Aeronautical Charting Forum 14-01

Instrument Procedures Group

April 29, 2014

AERONAUTICAL CHARTING FORUM (ACF)

V-343/JOXIT Feeder WP, Dillon, Montana

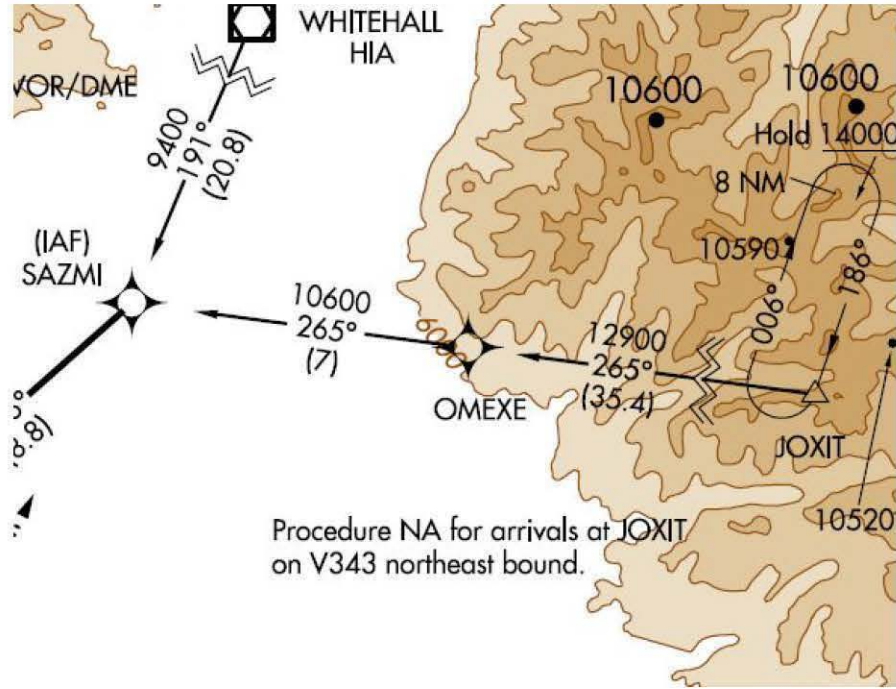
A recently implemented example is on the Dillon, Montana (KDLN) RNAV (GPS) Runway 17 SIAP, for an arrival on Victor Airway 343 from the south (illustrated in the attachment)*. Note that the course change from V-343 northbound onto the JOXIT feeder route is 101 degrees and prohibited by the JOXIT note. Instead, the JOXIT arrival holding pattern shown on the approach chart is an implicit course reversal to permit entry onto the JOXIT feeder route arriving on V-343 from the south.

*Note: A very recent change to V343 removed JOXIT from the airway structure. However, the issue remains since the limitation is reflected on SIAP chart and is found on other procedures within the NAS.

Recommendations: AFS-420 should commission a simulation study of both the 90 degree and 120 degree turn limits when RNAV equipment is used to navigate an airway-to-feeder route segment. The study should also evaluate the performance of RNAV systems when an arrival hold is used in lieu of a larger turn angle limit, and in particular the RNAV system performance leaving the holding fix (which are often treated as “fly-by” waypoint when exiting the hold) and joining the feeder route. NBAA believes such simulations will validate that a 120 degree course change is far preferable to an arrival hold “course reversal.”

If the FAA determines that it must retain the limit on airway to feeder (or initial segment) RNAV SIAPs to 90 degrees because of RNAV system performance, then consideration should be given to placing the same limit non-RNAV SIAPs since today RNAV systems are largely used to navigate these routes in lieu of the ground-based NAVAID. In addition, definitive, comprehensive policy needs to be provided to AeroNav Services that gives objective guidance about when arrival holding patterns must be included in original or revised RNAV and ground-based SIAPs. Consideration should also be given to establishing speed limitations on SIAPs that will allow the use of RNAV systems while supporting the existing 120 degree turn angle limit.

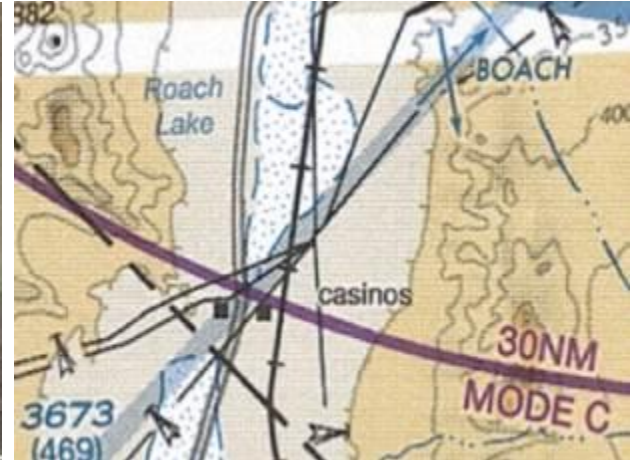
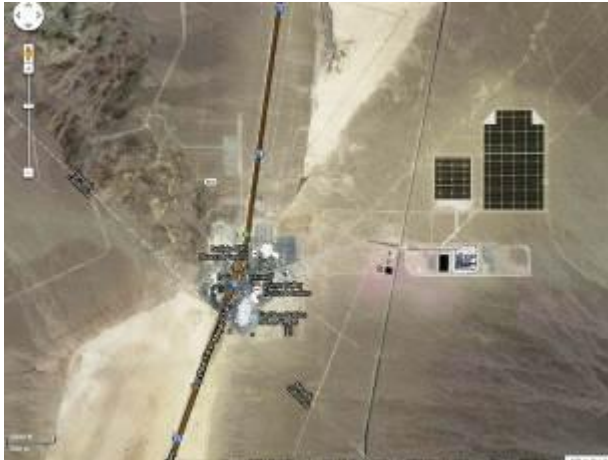
Define and establish aeronautical charting symbology for placement at large solar power plant sites that will identify;

1. The visual landmark for VFR navigational purpose.
2. This site has potential ocular hazard considerations.

Mat-Su Valley Designated CTAF Areas.jpg

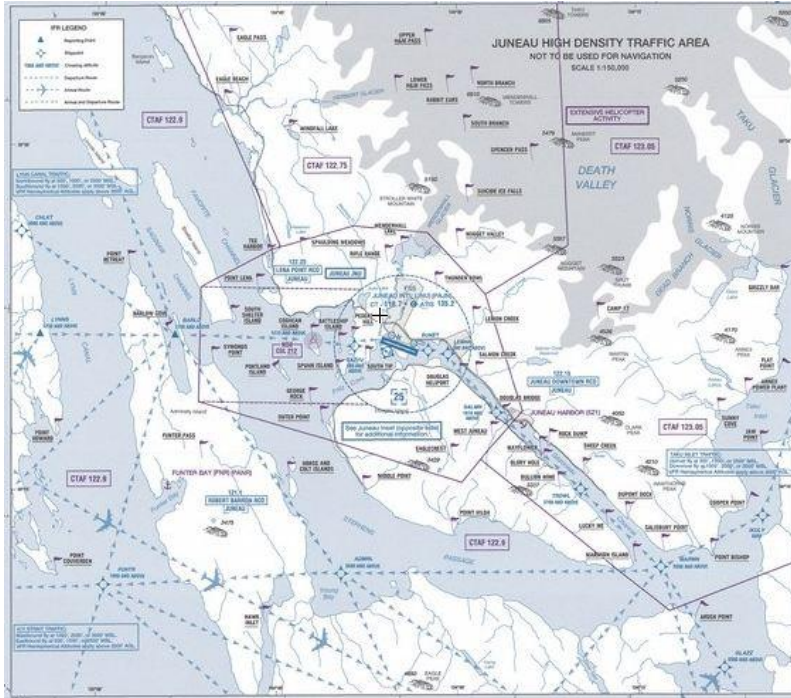
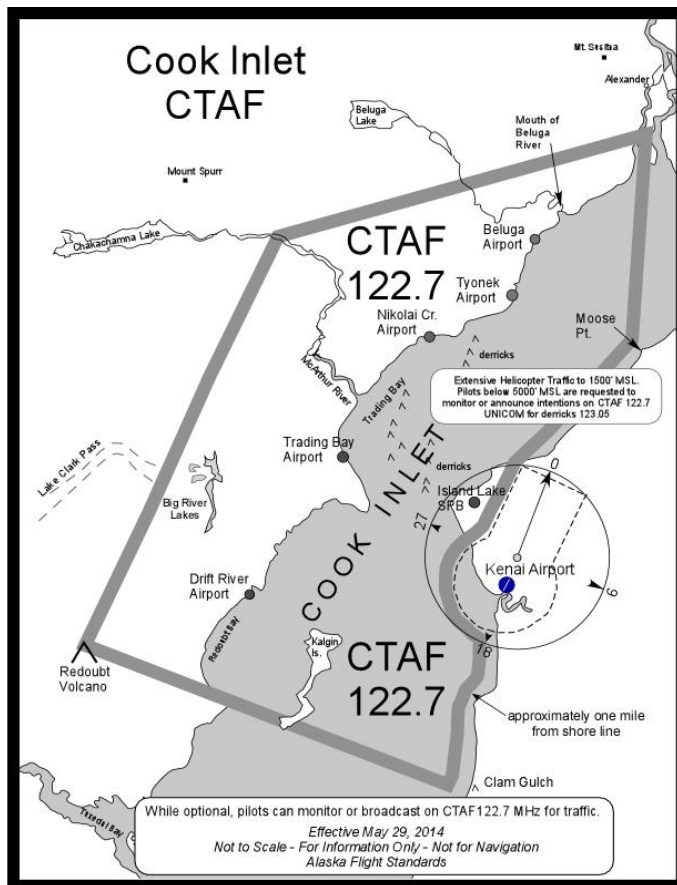
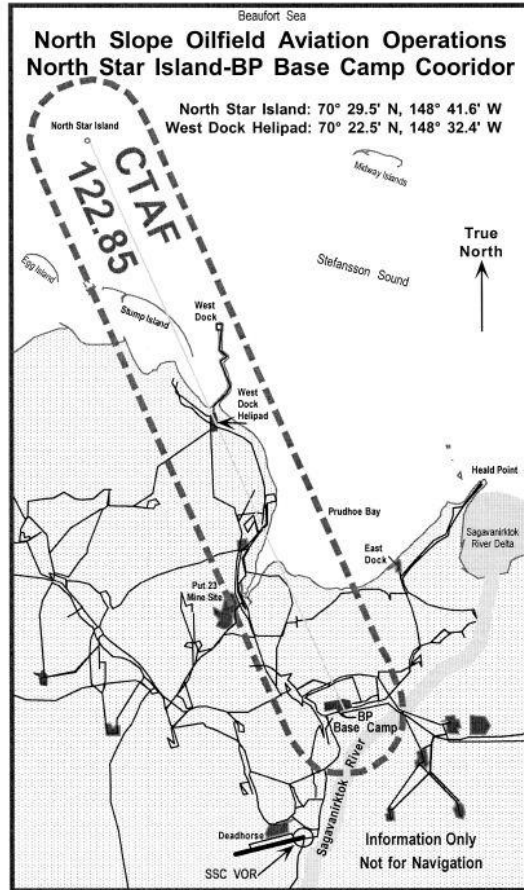
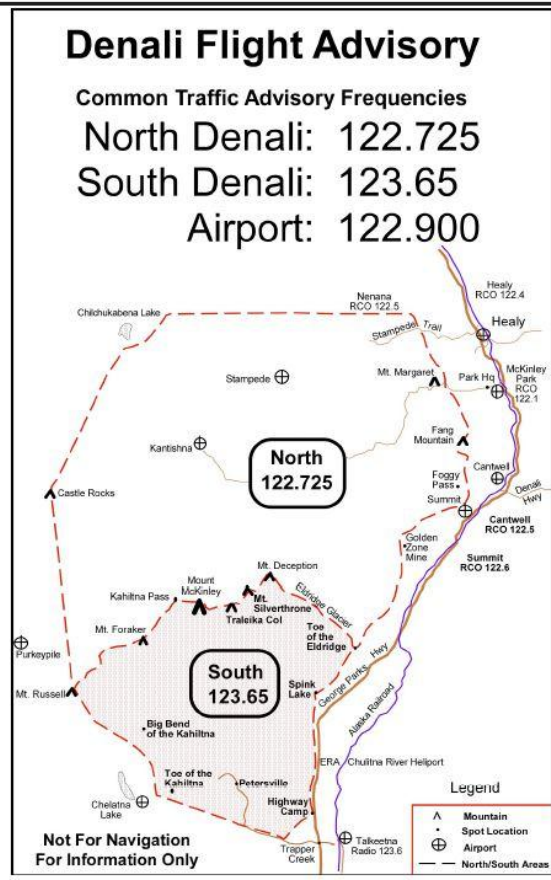
NTSB findings recently included a review of the CTAF frequencies used in the area around several accident sites and revealed the use of multiple primary radio frequencies, but due to the high concentration of aerodromes in the area, many of the frequency boundaries overlap.

The members of the Working Group examined existing guidance, conducted a pilot survey and sought direct input from FAA lines of business, military operators, general aviation and air taxi pilots and CFI's who use this airspace on a regular basis. A set of recommendations was made to reduce confusing guidance concerning CTAF frequencies (identified in the NTSB findings), and improve aviation safety. These recommendations included establishment of designated CTAF Areas for discrete geographic areas, as opposed to the standard 10 mile radius around an airport.

We recommend that charting conventions and symbology be developed to show CTAF Area boundaries for aeronautical charts in order to provide consistent CTAF information for airmen. This methodology should lead to a reduction in near mid-air collision by eliminating conflicting, confusing guidance and provides for easily accessible information. Conventions need to apply both to printed and electronic charts.
